Reply to RC1 (Stuart Pearson) :

This manuscript presents a hydrodynamic dataset for the Gambier Islands (French Polynesia) in the Pacific Ocean, detailing waves, currents, temperature, and water levels at multiple locations around an atoll for 9 months in 2019-2020. The entire atoll seems well-instrumented, with instruments suitable to capture a wide range of hydrodynamic phenomena.

Reply to RC2 (Robert Schlegel) :

Figure 3

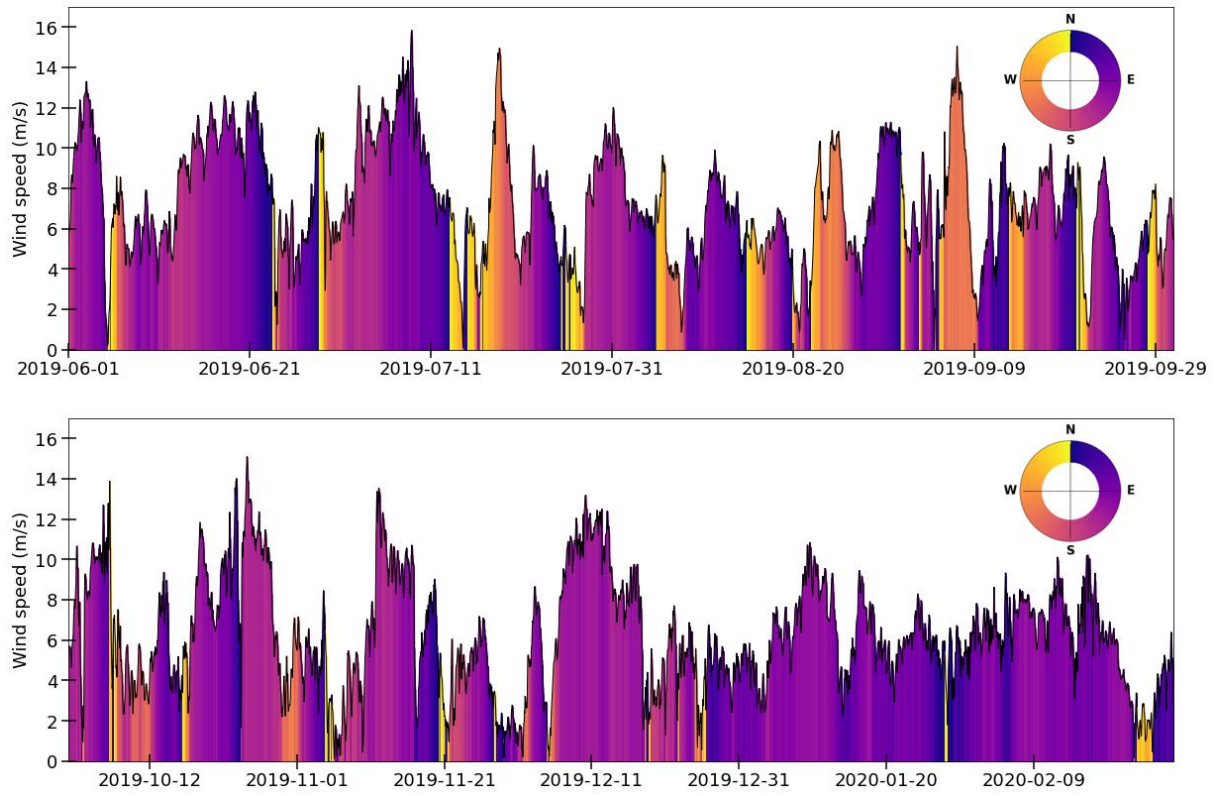
Rather use a non-rainbow colour palette to show wind direction. Such as one of the viridis colour palettes. "Wind directions follow meteorological convention" Meaning that the direction shown here indicates that is where the wind is coming from, or towards where it is going?

We have not modified the color palette as it was not mandatory, and also to keep the same palette as in other publications (*Andreofuet et al. 2023a*, *Bruyère et al. 2023a*). However, we have tried (below), but we don't like it as much as the rainbow palette!

For wind, the direction is where the wind is coming from (hence 0° is a wind coming from the North).
